Subject: NRC Meeting At Westinghouse 4/8/92
 Review Progress On Solvent Extraction
 Contamination Problem

On April 8, 1992, Tom Decker, U. S. Nuclear Regulatory Commission, visited the site to review the Westinghouse facility with respect to the problems noted in the solvent extraction area soil contamination incident and the response.

"HYDROPHONE" AND AUGER SOIL SAMPLING LOCATIONS

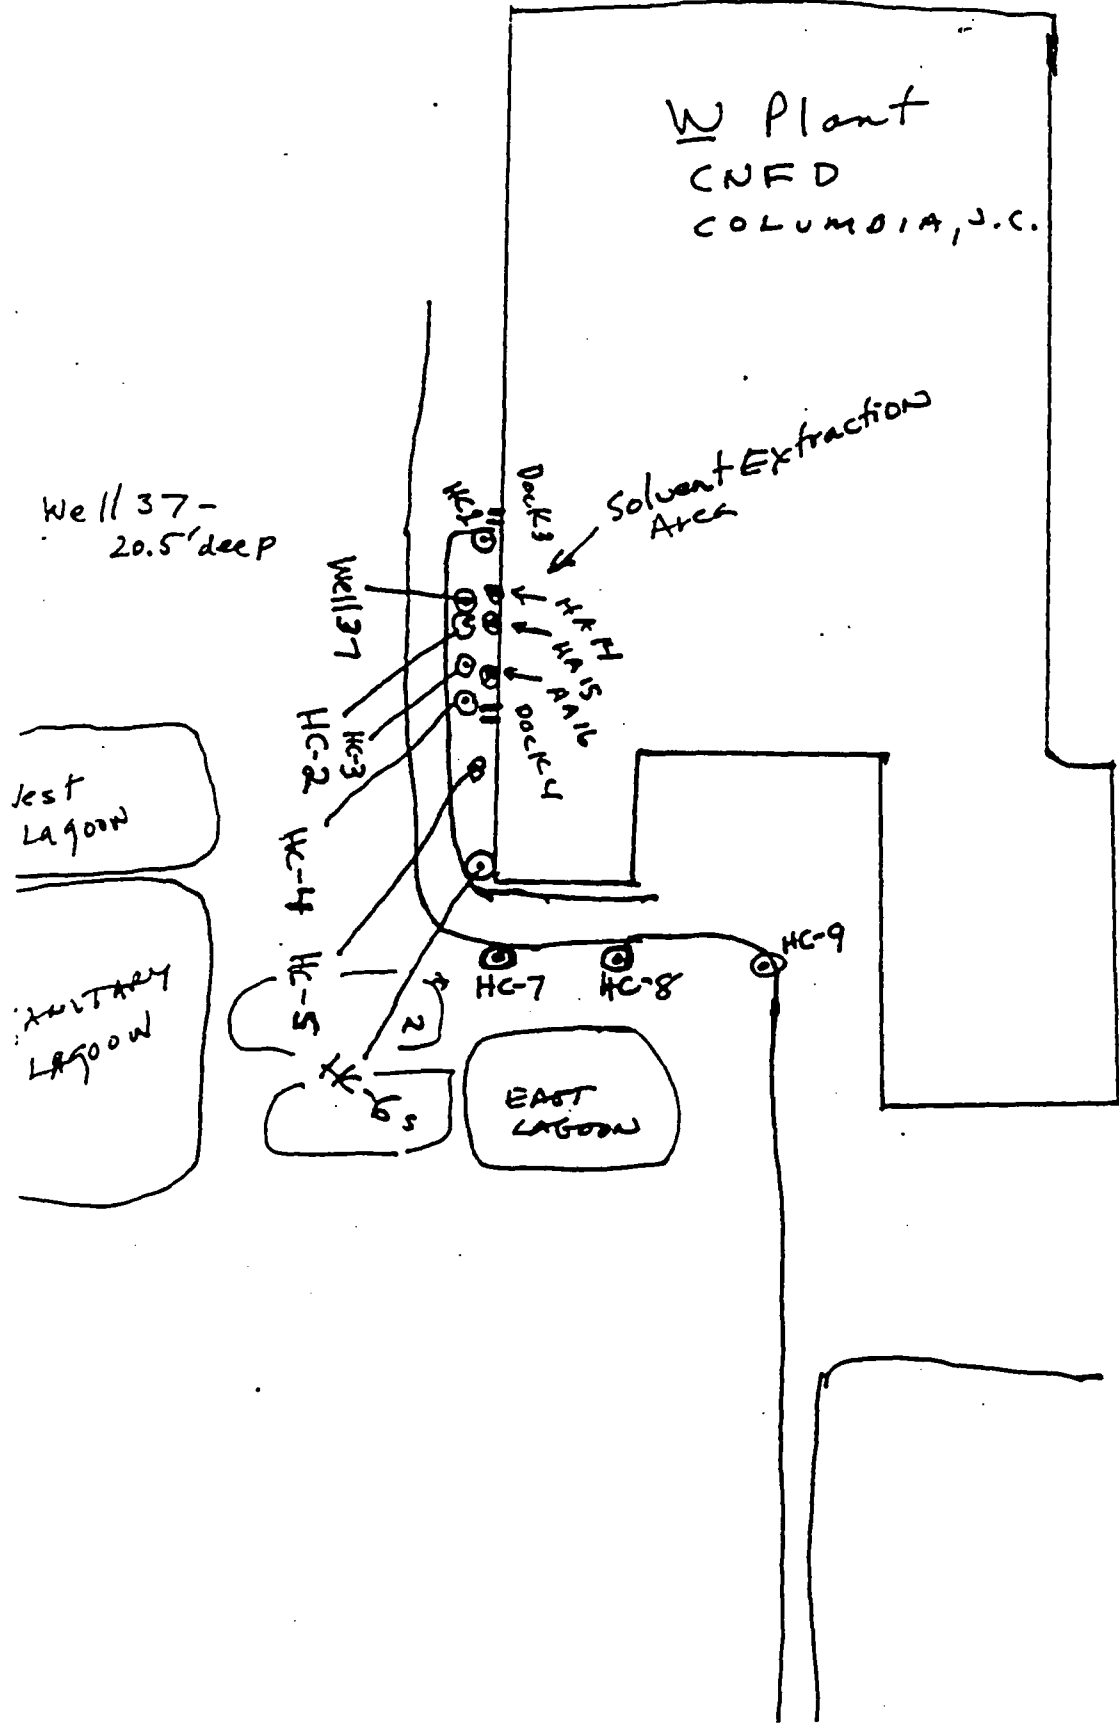
During the meeting the following items were noted by the inspector:

1. Evaluate the depth of the footers
2. Evaluate migration down the footers
3. Indicate site characterization numbers if any in report
4. Leak control procedure formalization
